Rezoning Transportation Analysis

Petition Number: 2022-200

Date	Description
4-27-23	First Review (TM)
05-24-23	Second Review (TM)
07-26-23	Third Review (TM)

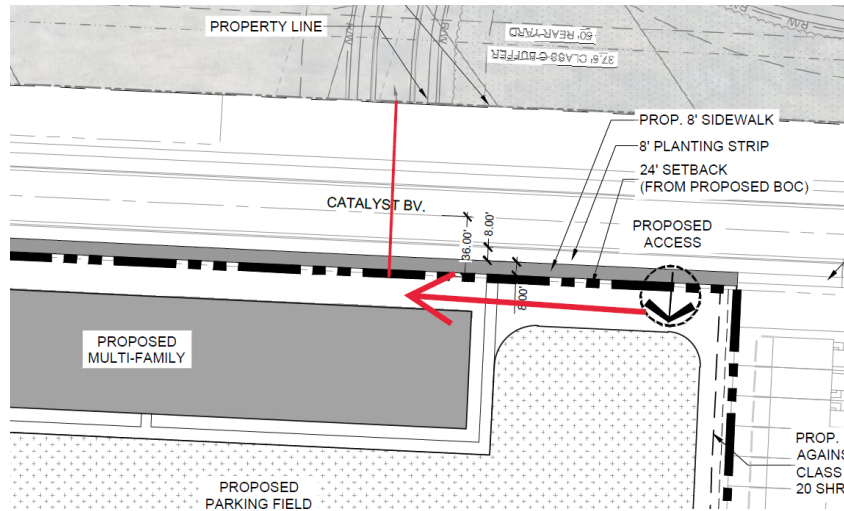
5. ~~Revise site plan and conditional note(s) to commit to construct bicycle facilities by installing a 12-foot multi-use path to meet the Council-adopted Charlotte BIKES Policy on IBM Drive. Multi-use paths maintained by the City shall meet ADA/PROWAG requirements.~~
